Dominion Nuclear Connecticut, Inc.
Millstone Power Station
Rope Ferry Road
Waterford, CT 06385

Millstone Nuclear Power Station, Unit No. 2
Reply to Request for Additional Information
Related to NRC Bulletin 2001-01

Reply to Request for Additional Information
Related to NRC Bulletin 2001-01

Figure 1 Location of UT indications in Nozzle 21 from 2R14 Inspection

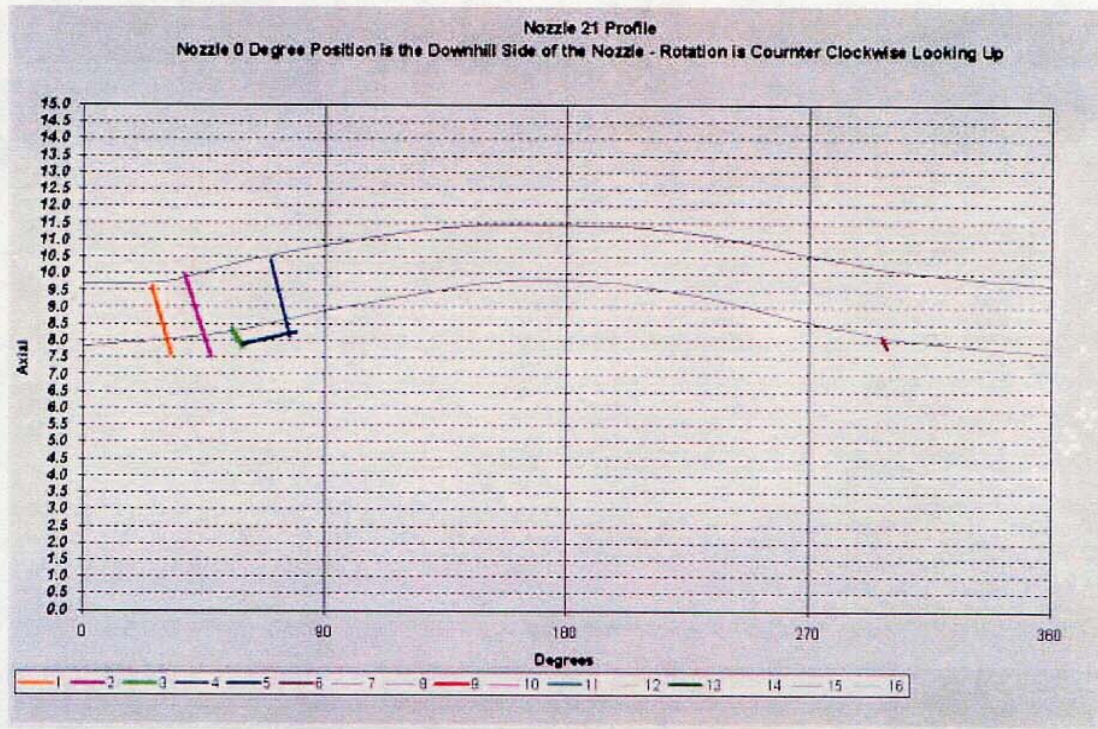
2. *The information in the three tables states that the location of each of the indications found is "OD downhill". The staff requests more specific information regarding the locations. If possible, please provide the information similar to that provided by in Figure 8 through 12 of the Root Cause Analysis Report for Davis-Besse dated April 18, 2002. These Figures are shown on the NRC website at:*

See Figure 1 through 3 on the following pages:
